DONALD C. COOK NUCLEAR PLANT UNIT NO. 1

AMENDMENT TO FACILITY OPERATING LICENSE

Amendment No. 18
License No. DPR-58

ATTACHMENT TO LICENSE AMENDMENT NO. 18

FIGURE 3.2-1 AXIAL FLUX DIFFERENCE LIMITS AS A FUNCTION OF RATED THERMAL POWER

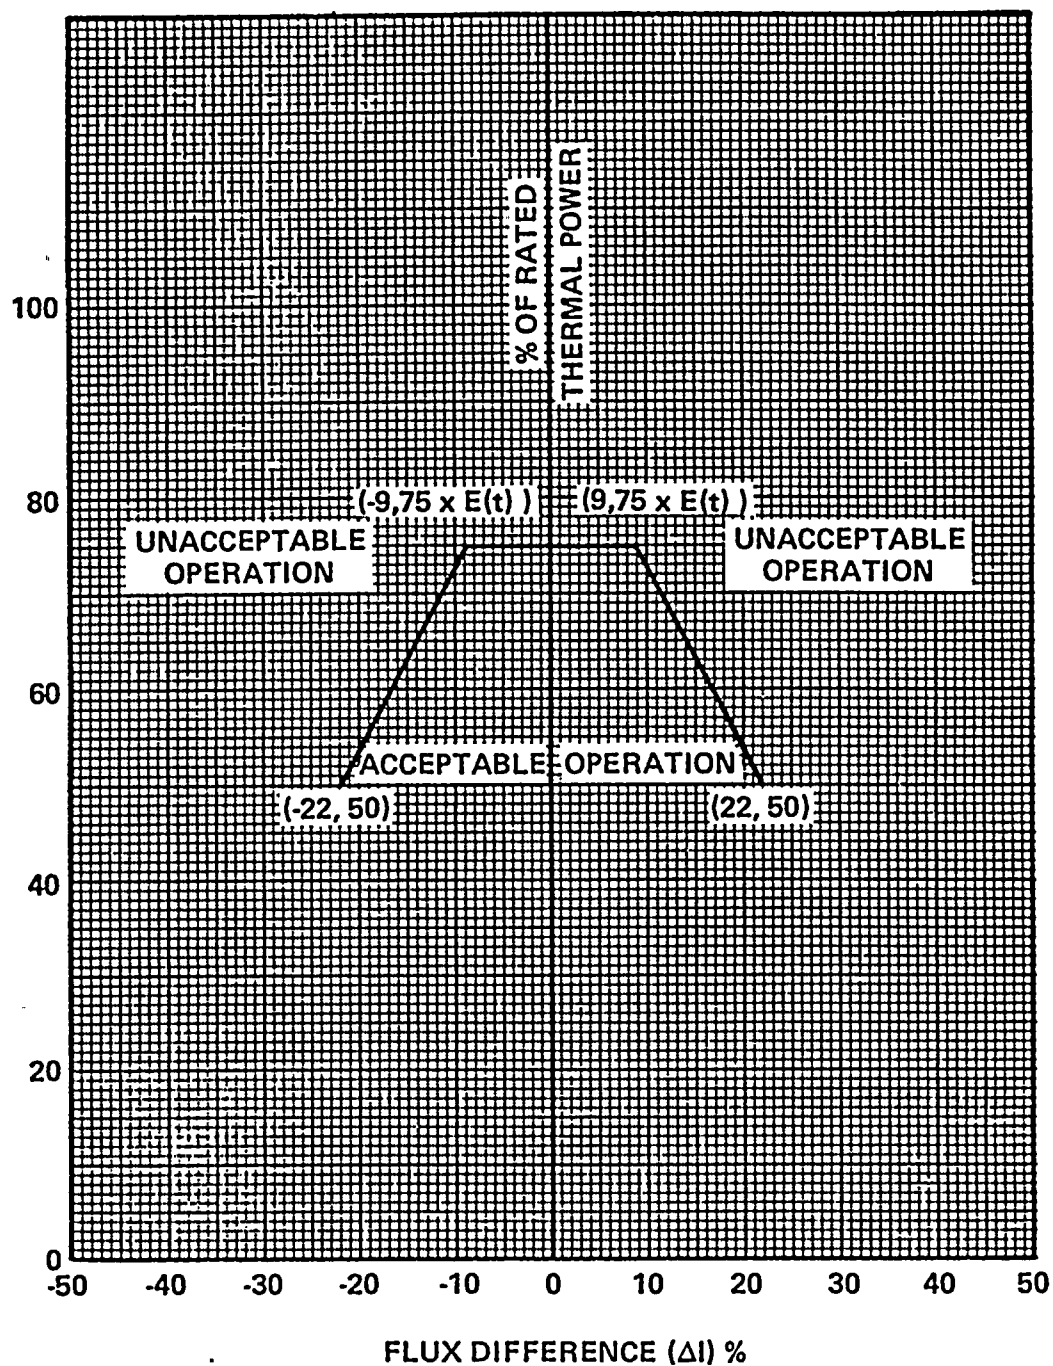
3.2.1 The indicated AXIAL FLUX DIFFERENCE (AFD) shall be maintained within a +5% target band (flux difference units) about the target flux difference shown on Figure 3.2-4.

- 2) The indicated AFD is within the limits shown on Figure 3.2-1. Otherwise, reduce THERMAL POWER to less than 50% of RATED THERMAL POWER within 30 minutes and reduce the Power Range Neutron Flux-High Trip Setpoints to $\leq 55\%$ of RATED THERMAL POWER within the next 4 hours.

Figure 3.2-3 $E(t)$ Normalized Core Power as a Function of Cycle Burnup

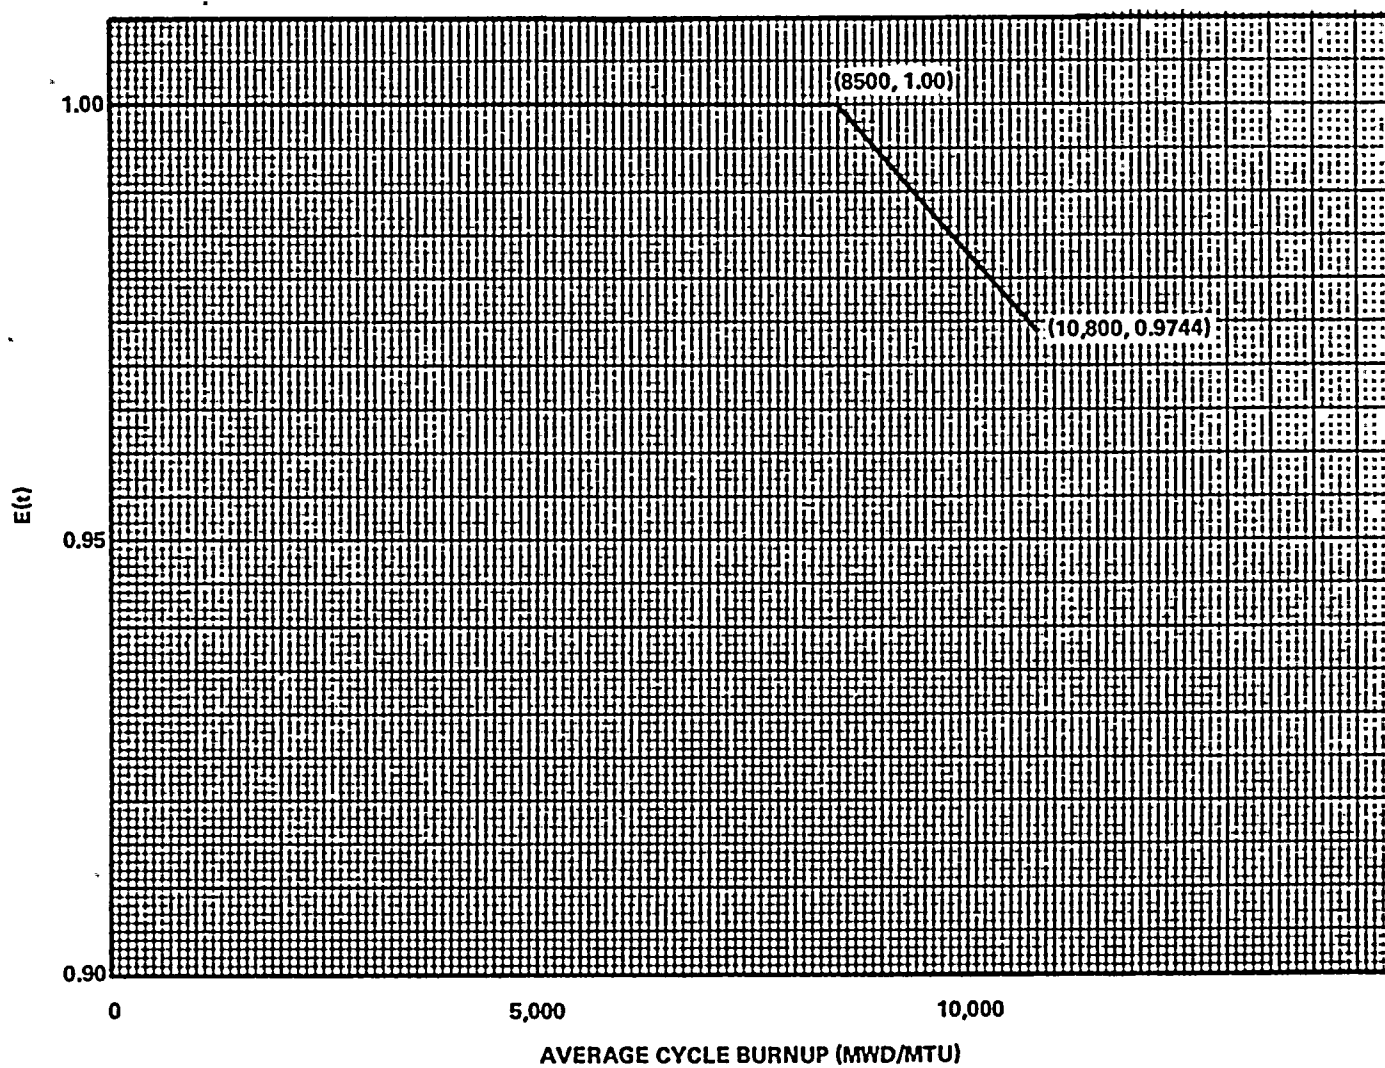
$\#E(t)$ is defined on Figure 3.2-3

$E(t)$ is defined on Figure 3.2-3,
